NOTICE OF INTENTION TO REVISE LARGE MINING OPERATIONS

1. Name of Operator/Applicant: JUMBO MINING COMPANY
2. Address: 6305 FERN SPRING COVE
AUSTIN, TEXAS 78730
3. Phone #: (512) 346-4537
4. Name of Operation/Project: DRUM MINE--NEW HEAP
5. Previously Assigned File #
(from original Notice of Intention): M/027/007
6. Location of Proposed activities

A NEW HEAP WILL BE CONSTRUCTED WEST OF OLD HEAP #2 AND WEST AND NORTH OF OLD HEAP #3. THE HEAP IS DESIGNED TO HOLD UP TO 800,000 TONS OF ORE. STARTUP DATE IS SCHEDULED IN MAY-JUNE, 1991

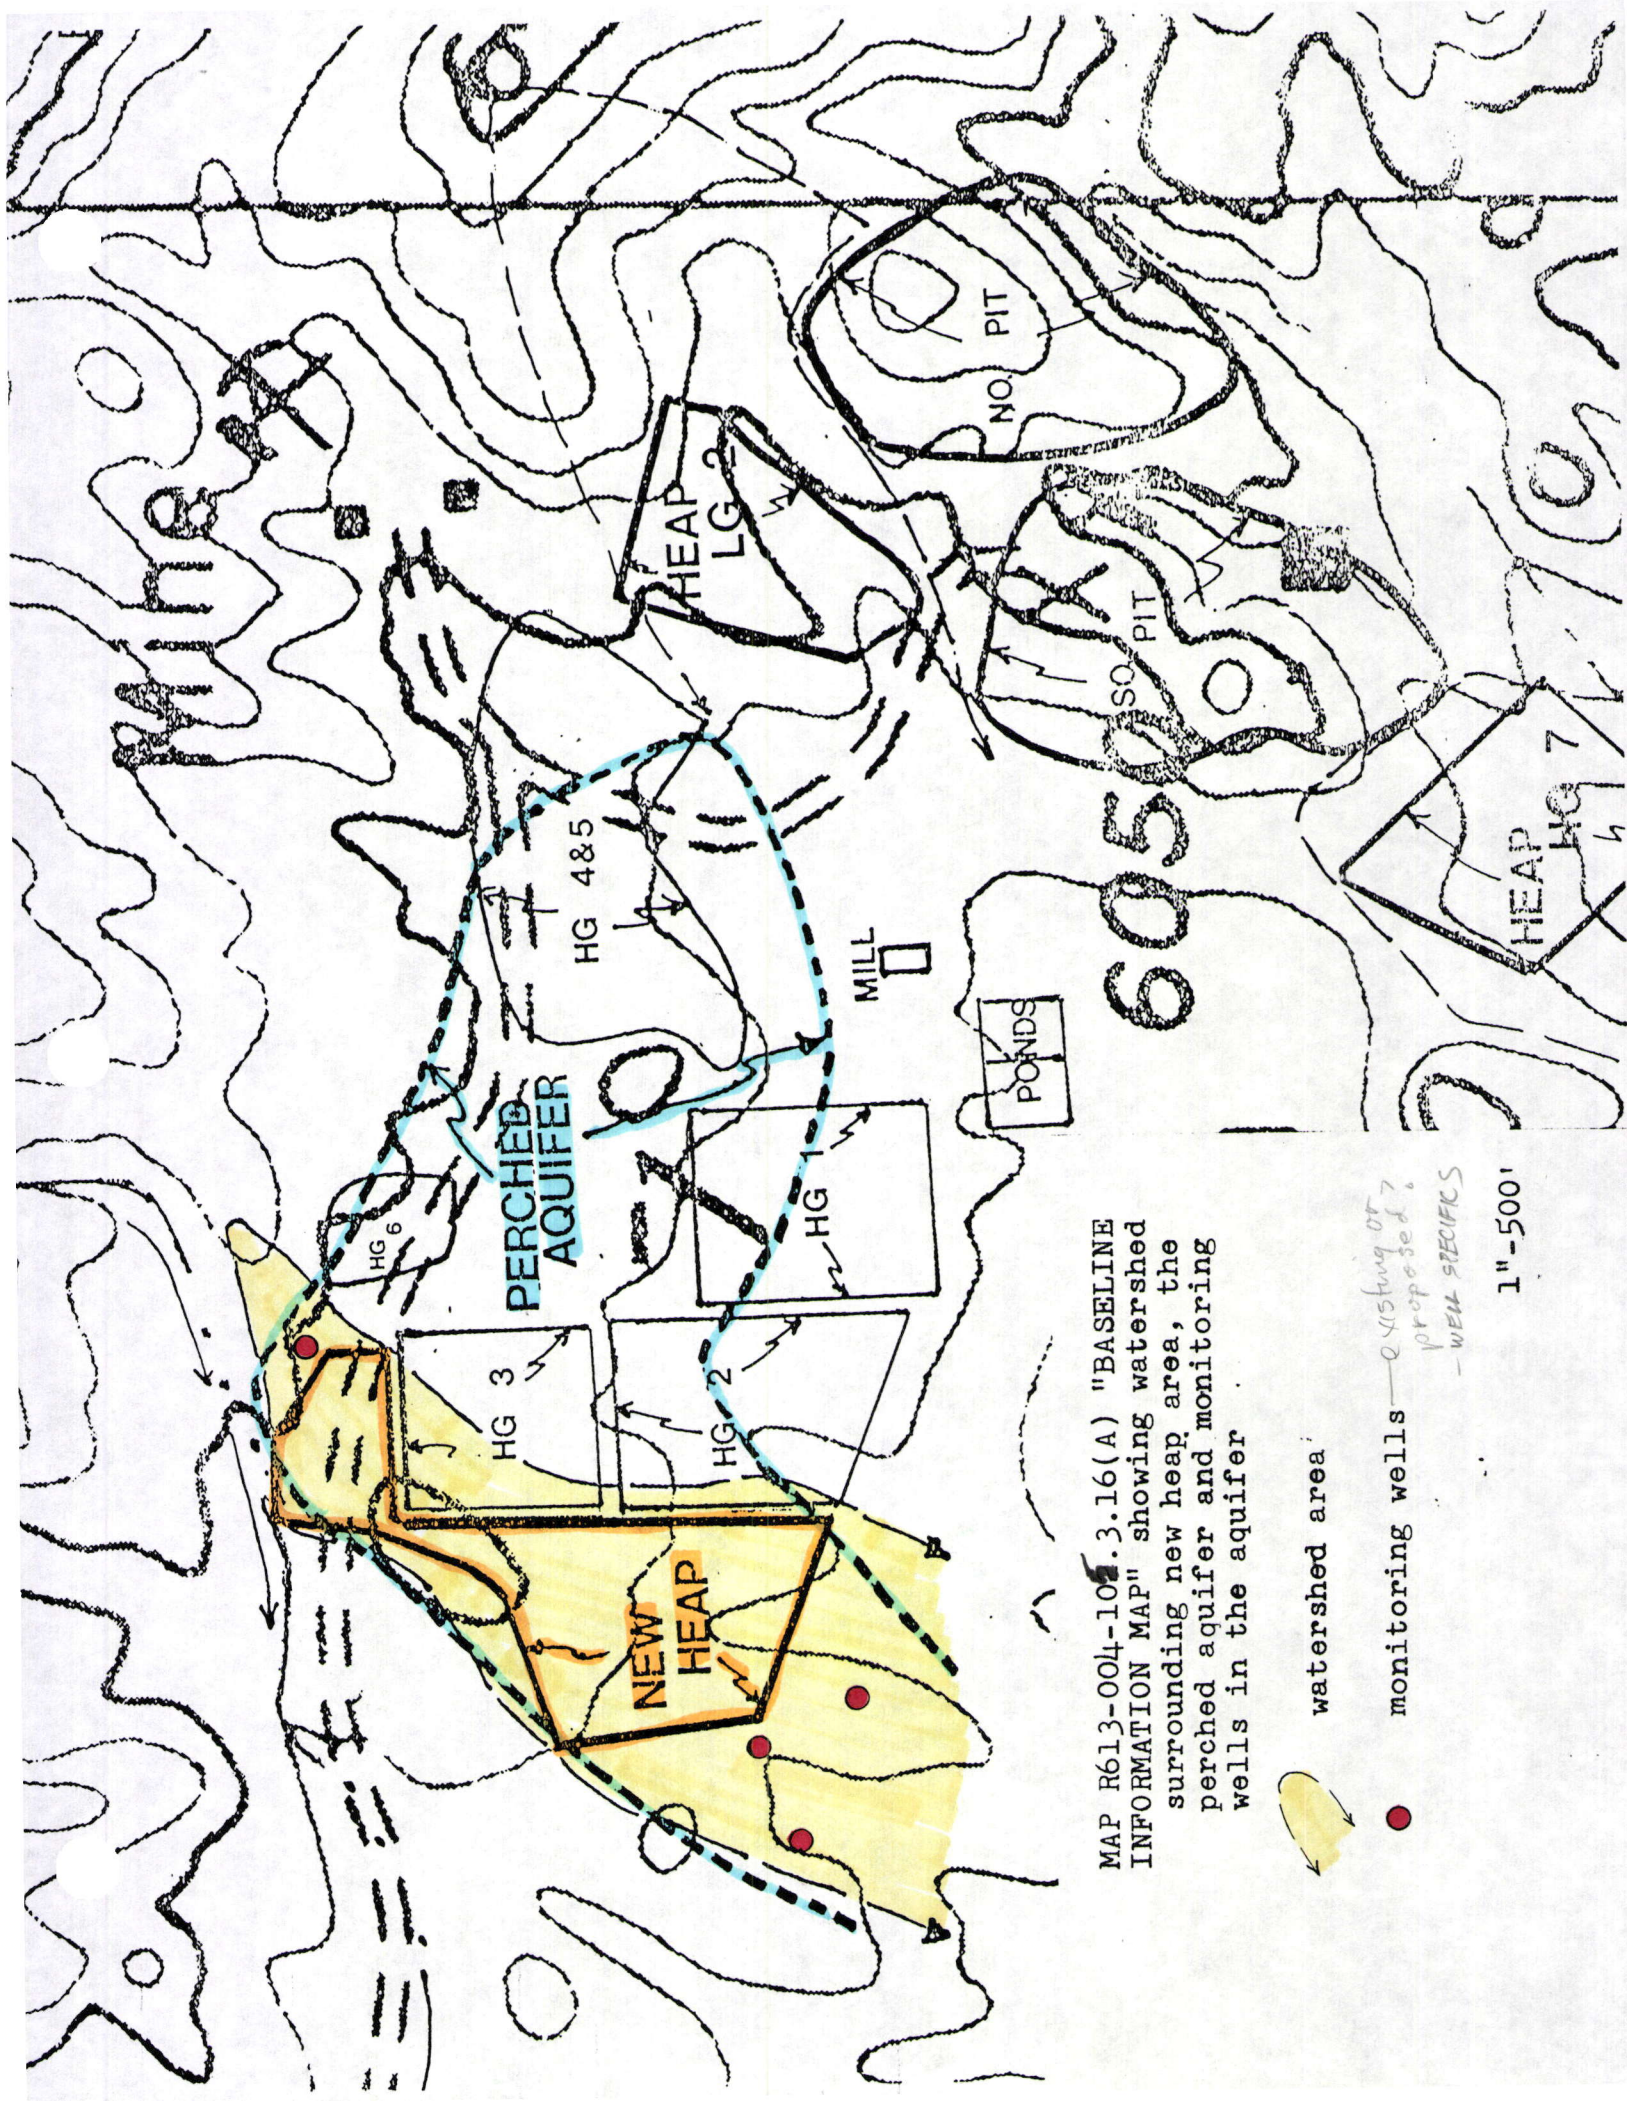
<u>DESCRIPTION</u>	<u>AMOUNT</u>	<u>\$/UNIT</u>	<u>COST-\$</u>
Ripping new roads	0.72 Acres	545	293
Contouring and regrading heap sides <i>(to a 2:1 ???)</i> <i>or 3:1</i>	7.91 Acres	394	3,116
Spread topsoil on heap	15,606 CY	0.68	10,612
Clean up trash	15.99 Acres	0.47	752
Scarify and seed	7.30 Acres	286	2,088
Construct additional fence	1200 Feet	1.00 <i>??</i>	1,200
<u>TOTAL</u>			18,061

*Nothing for neutralizing heap.
Monitoring of water.*

MAP R613-004-105.
3.16 (B) "GEOLOGY"

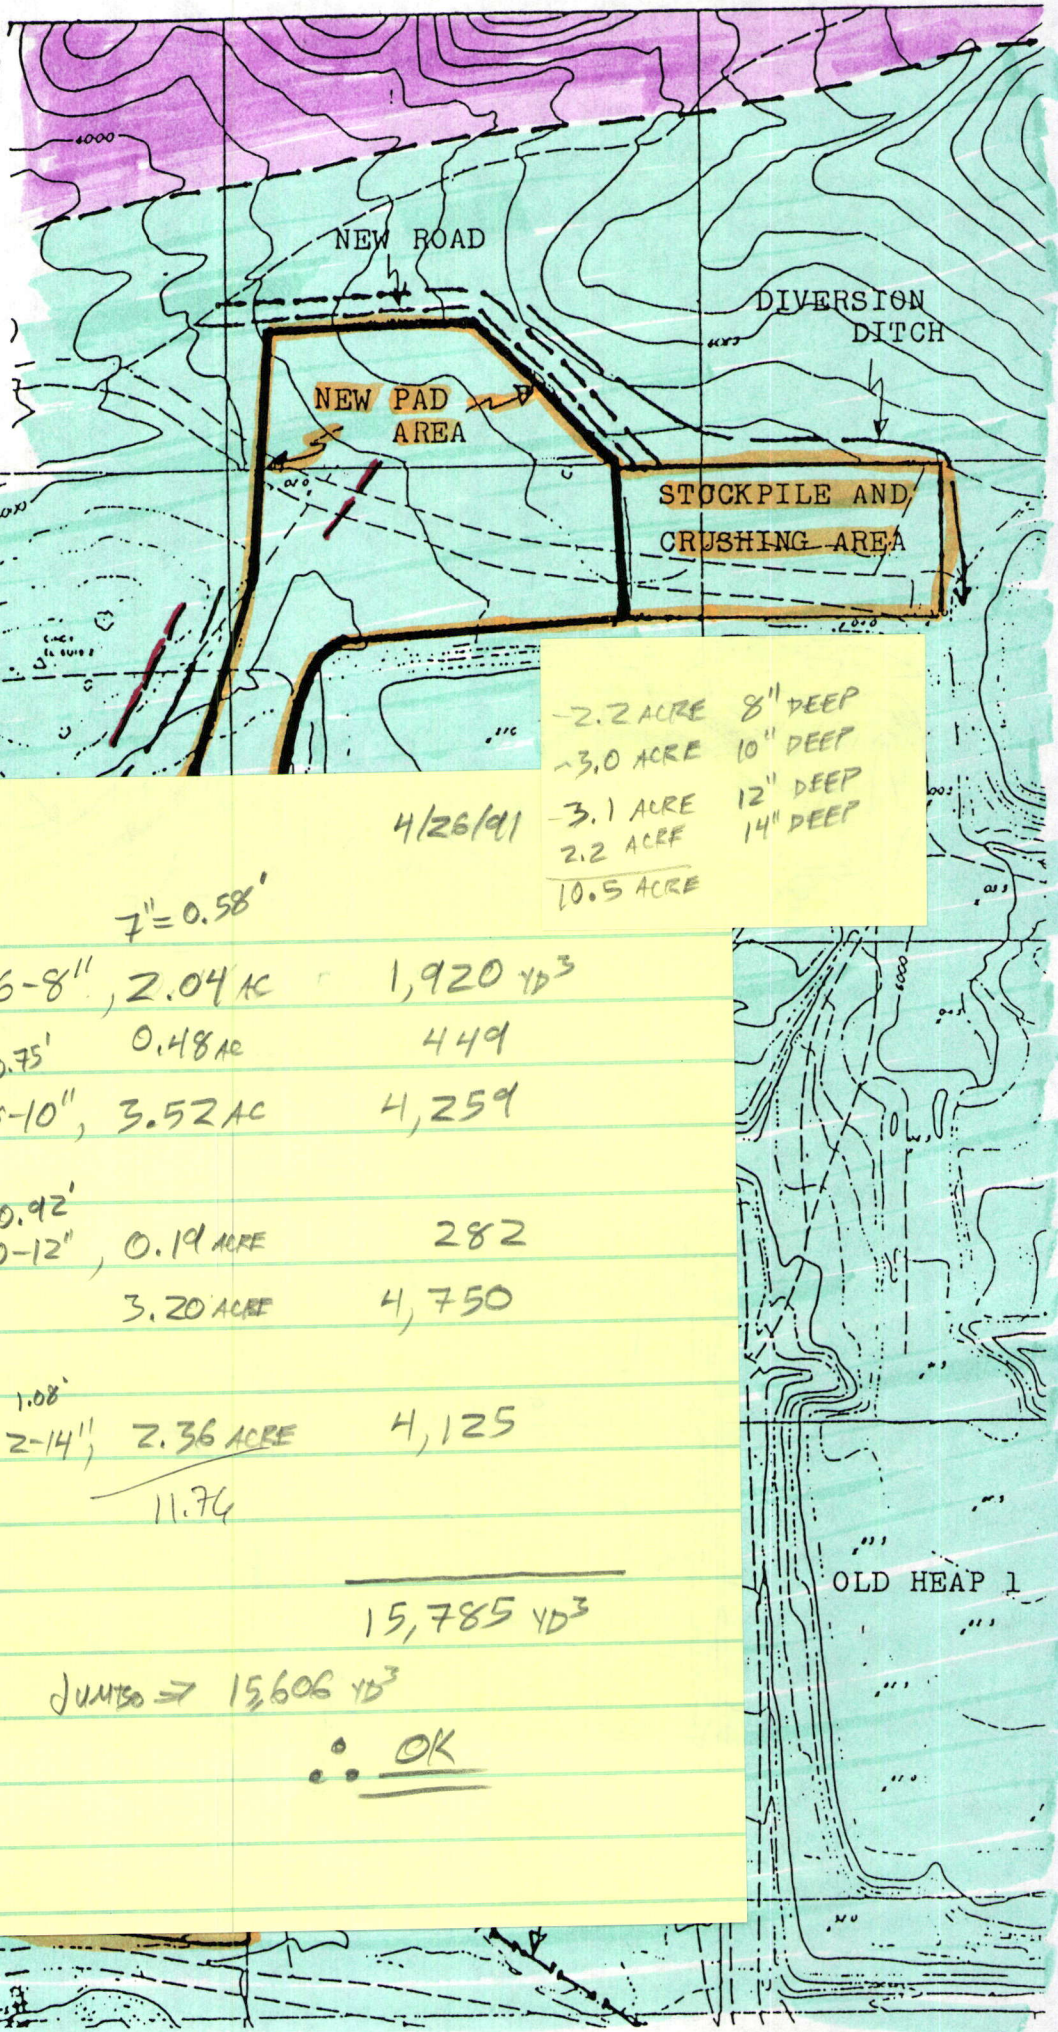
-2.2 ACRE	8" DEEP
-3.0 ACRE	10" DEEP
-3.1 ACRE	12" DEEP
2.2 ACRE	14" DEEP
<hr/>	
10.5 ACRE

$7" = 0.58'$

6-8"	2.04 AC	1,920 yd ³
0.75'	0.48 AC	449
8-10"	3.52 AC	4,259
0.92'		
10-12"	0.19 AC	282
3.20 AC		4,750
1.08'		
12-14"	2.36 AC	4,125
<hr/>		
11.76		
<hr/>		
		15,785 yd ³
<hr/>		
Jumbo	15,606 yd ³

OK

MAP R613-004-104.
2.12 "NEW ACREAGE
TO BE DISTURBED"

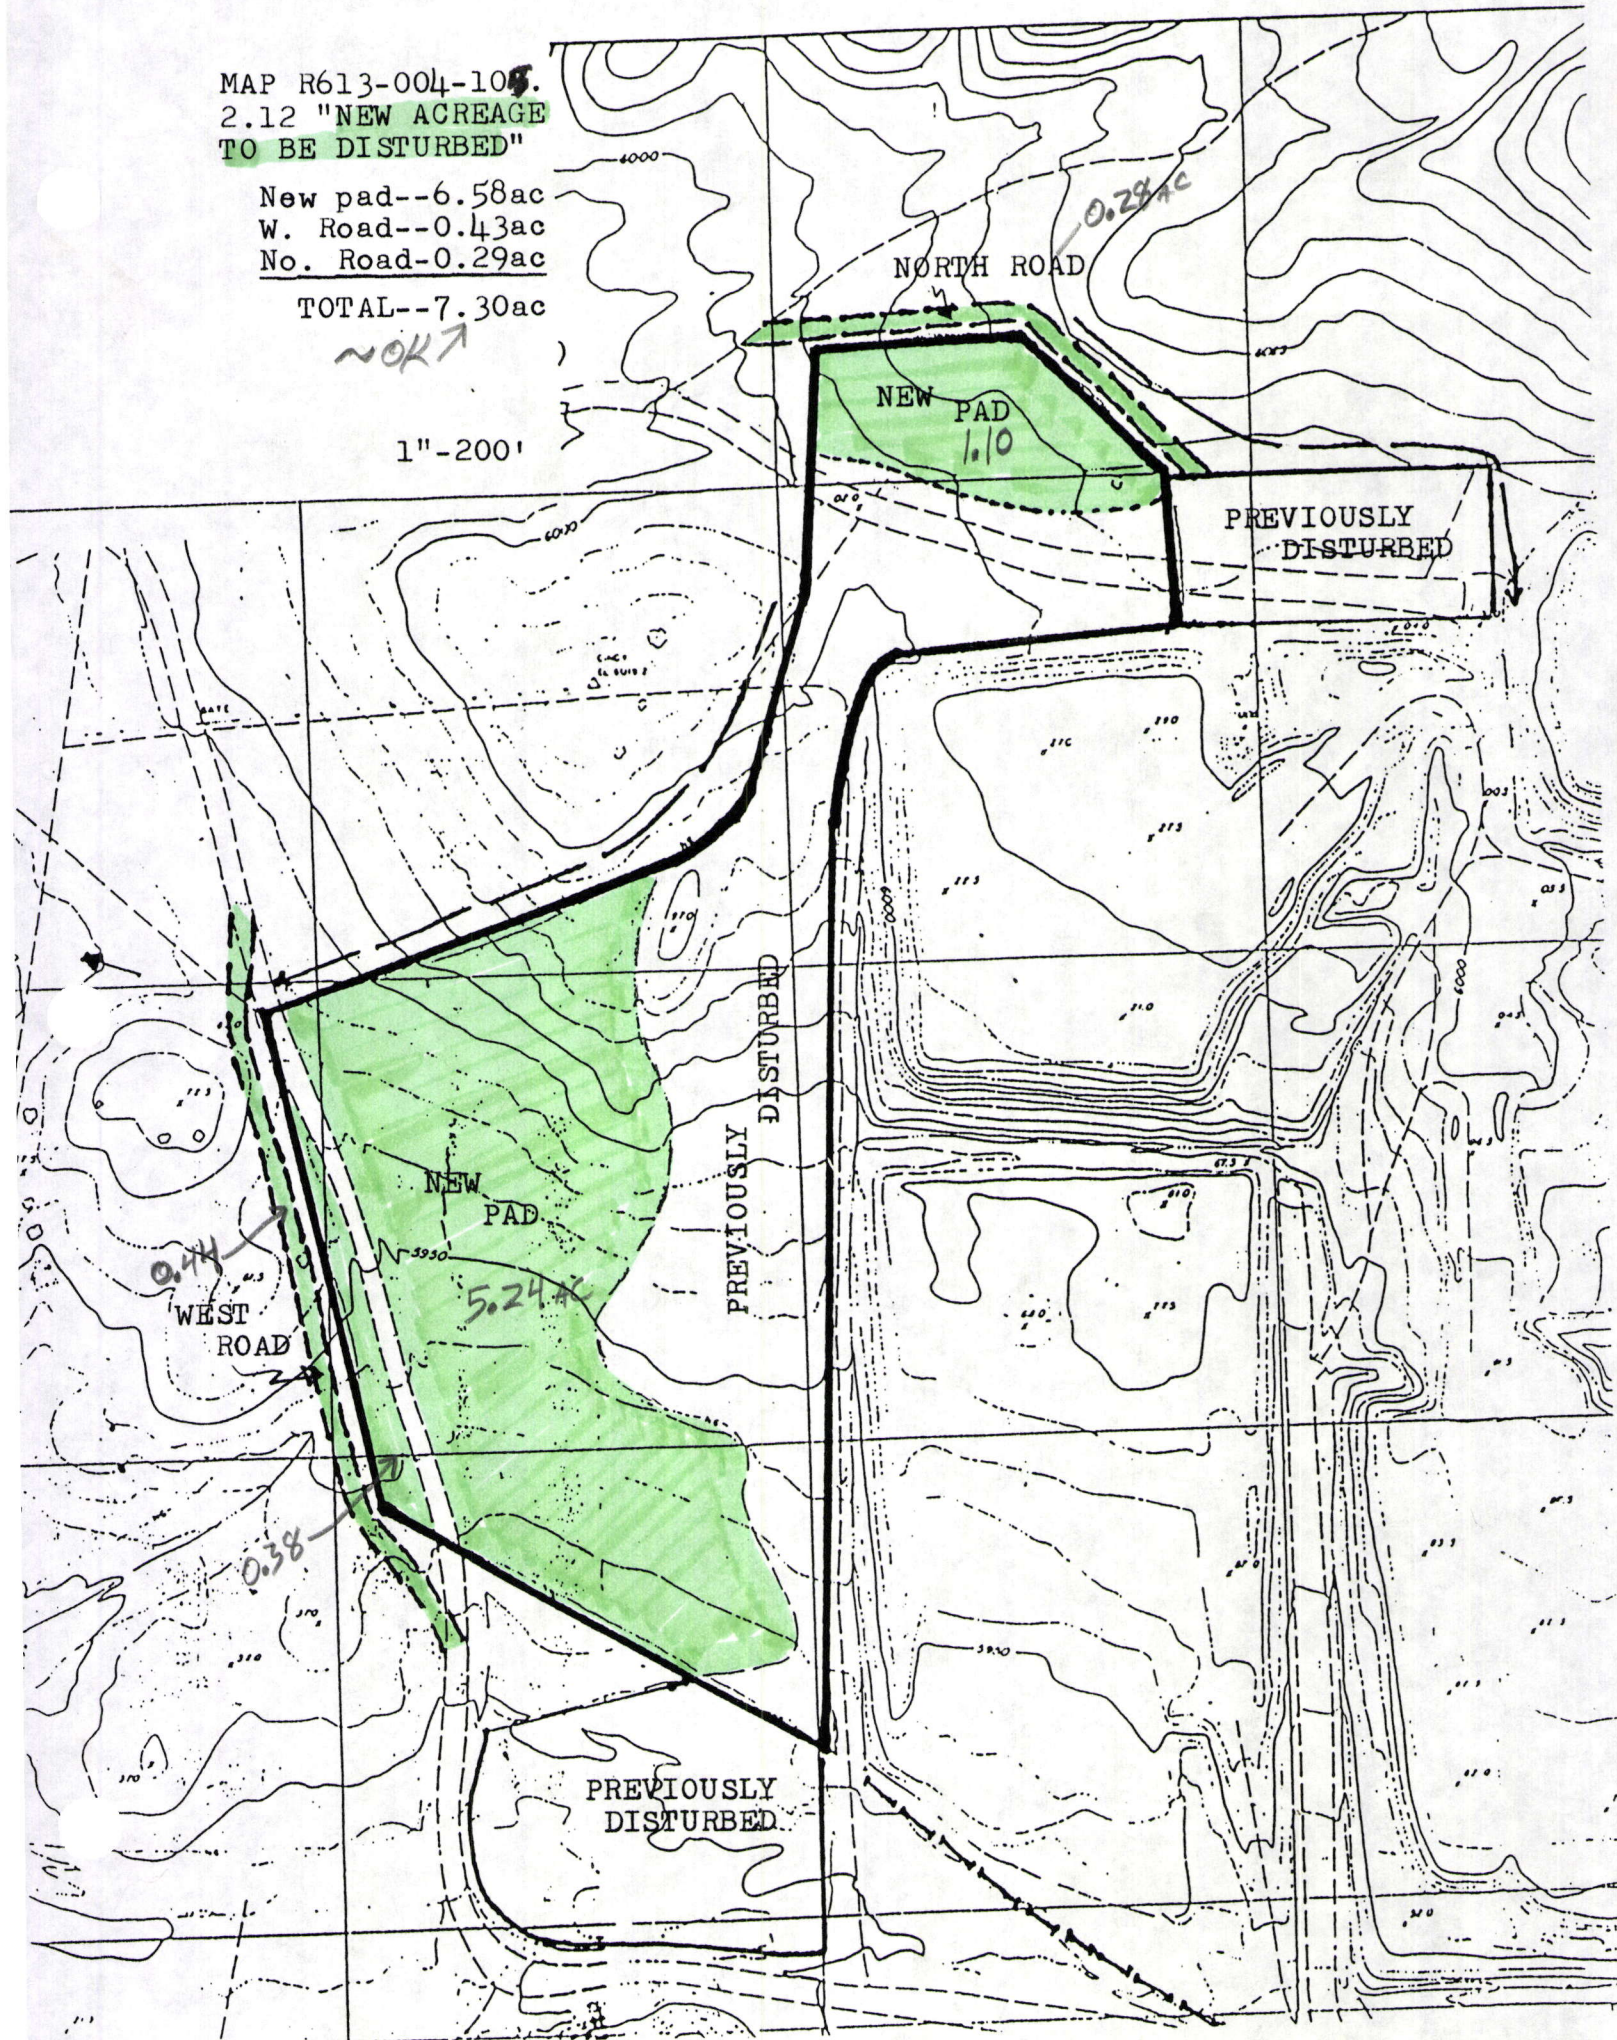
~OK~
